# Access Compliance Report

## Public Rights-of-Way

Intersection ID: 27440	Main Street: BALLANTYNE COMMONS PY	Cross Street: DOWINGTON DR	Location: SE
ADA ID: 3229948305C6	Ramp Type: Perp	Initial Pass/Fail: Fail	Overall Compliance: No
		Severity Score: 8.75

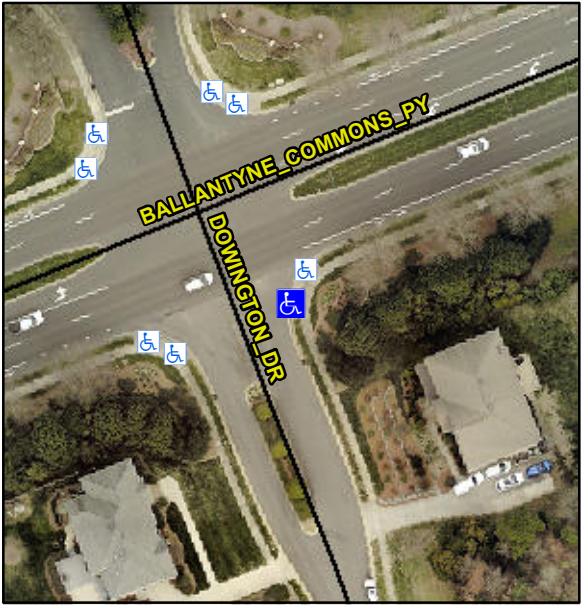
Codes/Mitigation Info/Possible Solution		Field Measurements/Component Compliance			
	Possible Solutions:				
	Remove & Replace Entire Ramp.				
	Surveyor Notes:				
	N/A				
	PROW/ADA:				
	Not Found, R304.5.1				
Street 1 Name	DOWINGTON DR				
Stop Condition-Street 2	StopSign				
Street 2 Name	N/A				
Stop Condition-Street 1	N/A				
Total Cost:		\$	1850.00

Compliance	Description	Data	Compliance	Description	Data
N/A	Ramp Length (in)	108.0	Yes	Ramp Slope (%)	5.2
No	Ramp Width (in)	37.0	Yes	Ramp XSlope (%)	0.0
N/A	Flare Type LT	N/A	N/A	Flare Type RT	N/A
N/A	Flare Slope LT (%)	N/A	N/A	Flare Slope RT (%)	N/A
N/A	Flare Traversable LT?	N/A	N/A	Flare Traversable RT?	N/A
N/A	Landing Length (in)	N/A	N/A	DWS Provided?	N/A
N/A	Landing Width (in)	N/A	N/A	DWS Contrast?	N/A
N/A	Landing Slope (%)	N/A	N/A	DWS Length (in)	N/A
N/A	Landing X Slope (%)	N/A	N/A	DWS Full Width?	N/A
N/A	Landing Curb? (Y/N)	N/A	N/A	DWS Offset (in)	N/A
N/A	Shared Landing?	N/A			
N/A	Gutter Ponding?	N/A	N/A	Gutter Slope (%)	N/A
N/A	Gutter Lip Ht (in)	N/A	N/A	Gutter X Slope (%)	N/A
N/A	Painted X Walk1?	No	N/A	Painted X Walk2?	N/A
	X Walk 1 Direction	To W		X Walk 2 Direction	N/A
N/A	X Walk 1 Width (in)	N/A	N/A	X Walk 2 Width (in)	N/A
	X Walk 1 Slope (%)	0.5		X Walk 2 Slope (%)	N/A
	X Walk 1 X Slope (%)	2.2		X Walk 2 X Slope (%)	N/A

N/A	Ramp inside XWalk1?	N/A	N/A	Ramp inside XWalk2?	N/A
	Road Slope (%)	N/A	N/A	Clear Space?	N/A
	Road X Slope (%)	N/A	N/A	Clear Space to XWalk (in)	N/A
N/A	Any Obstructions?	N/A	N/A	Storm Grate/Utility Hazard?	N/A
	Obstruction Type			Storm Grate/Utility Type	
		N/A			N/A
			Yes	Surface Condition? (G/P)	Good
